**AMENDMENTS TO THE DRAWINGS**

### **REMARKS**

FIG.11

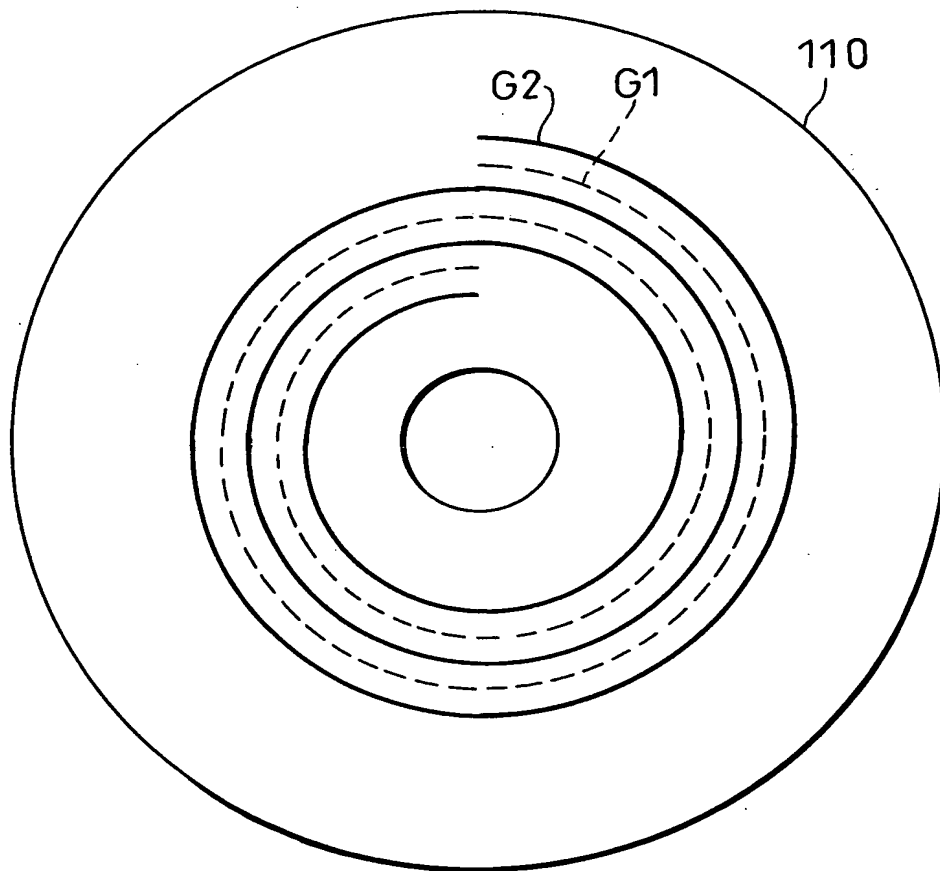
Please amend Figs. 11 and 12 by adding the legend "PRIOR ART" to each Figure as shown on the accompanying annotated drawing sheets and on the accompanying replacement drawing sheets.

The foregoing amendments in the drawings add the notation "PRIOR ART" to reflect, as the Examiner correctly notes, that Figures 11 and 12 show prior art constructions.

PRIOR ART
